STAFF REPORT

PROCEEDING NO. 20I-0437E

IN THE MATTER OF THE INVESTIGATION INTO THE HISTORY AND CONTINUING OPERATIONS OF THE PUBLIC SERVICE COMPANY OF COLORADO COMANCHE UNIT 3 GENERATING STATION PURSUANT TO DECISION NO. C20-0505.

March 1, 2021

Figure 15. Original P&ID of lube oil system (top) vs. revised P&ID (bottom).

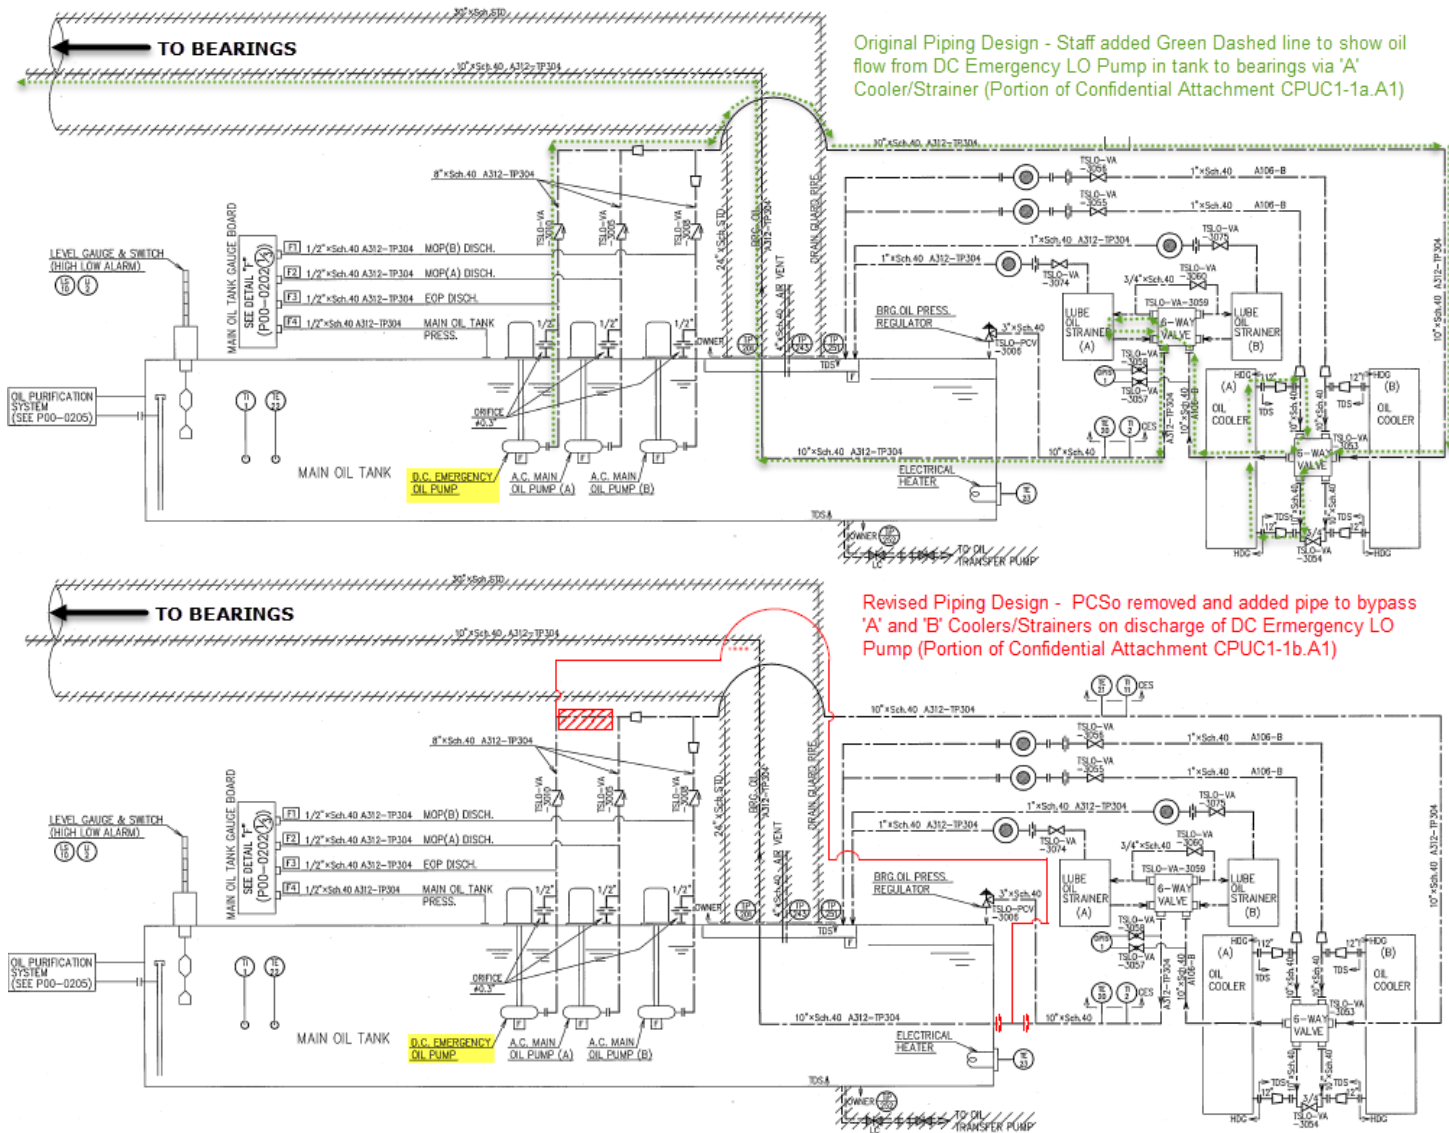
- *TLO Cooler TLO Backup Source.* The TLO Cooler 6-Way Valve was the single point of failure for the June 2, 2020 incident. When the valve stop pin failed, it allowed plant personnel to position valve such that it isolated TLO flow to critical turbine components and also isolated TLO flow from the emergency backup TLO pump.

As mentioned earlier, the original piping design which did not provide the ability for lube oil provided by the DC emergency oil pump to bypass the TLO coolers and filter sets is contrary to industry best practices which recommends

The Technical Design Team, as part of the TLO system corrective actions, removed a section of pipe and added additional piping allowing the DC emergency TLO pump to bypass cooler/filters and feed directly to bearings. Figure 13 illustrates the redlined piping and instrumentation diagram (P&ID) of the system.

Figure 16. Valve sketch (1 of 2).

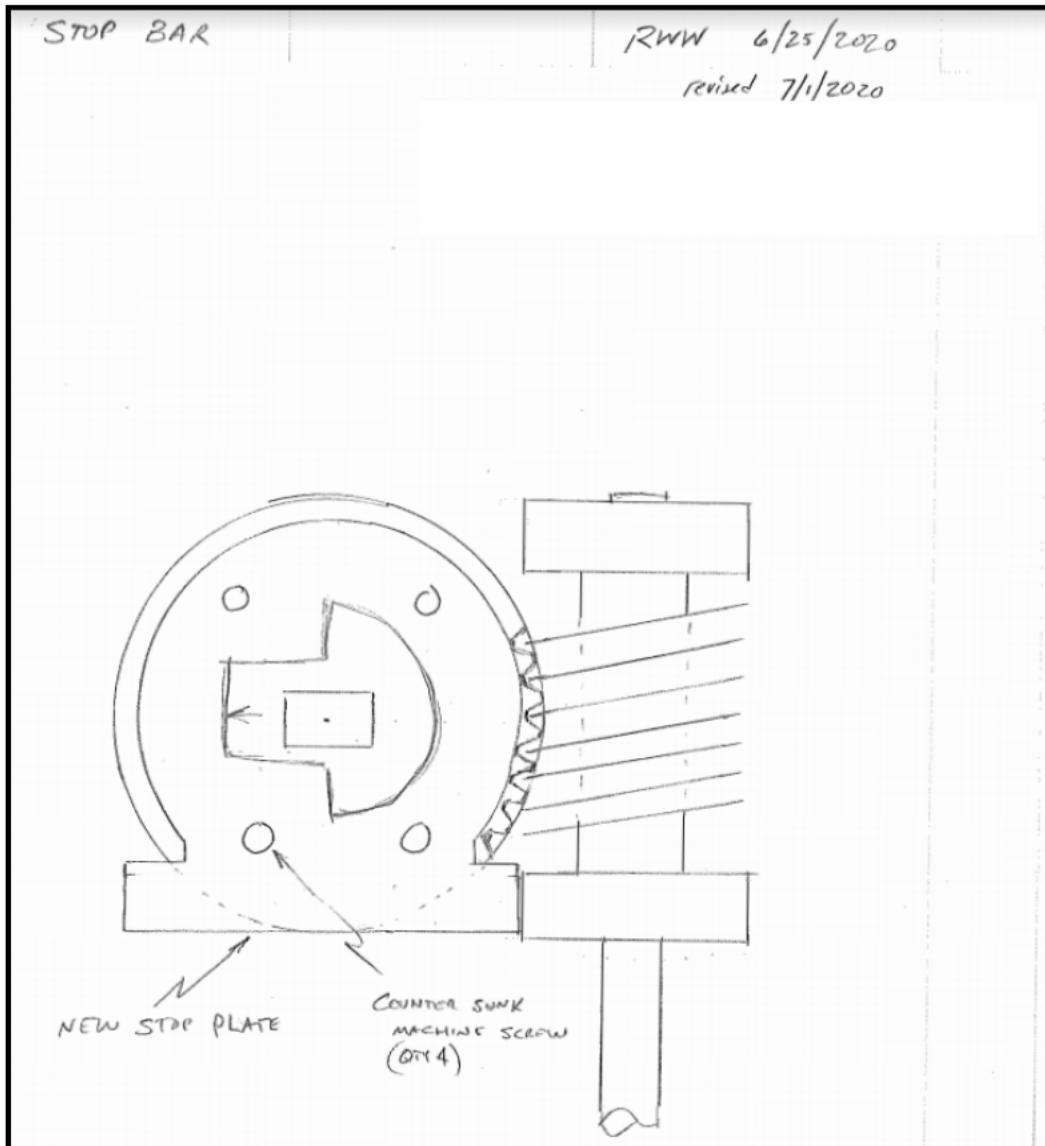
It was noted that the drawings were created and signed by the Technical Improvement Team Lead, who also happens to be the Plant's Manager of Reliability. There was no secondary or independent signature that demonstrated that the design was reviewed or verified. As is apparent by the single signature, design changes appear to have been made also without independent verification. There was no indication of the materials used for the modifications to the valve. There is no discussion of why modifications were made necessary (e.g. the result of a previous incident or identified by a SPOF analysis). There is no indication of what service standard was used, nor was there any indication that the drawings were filed or input into the plant's drawing system for future reference or traceability.

While this is may be a minor design change, it is essential to create a record of what modifications were made and why.
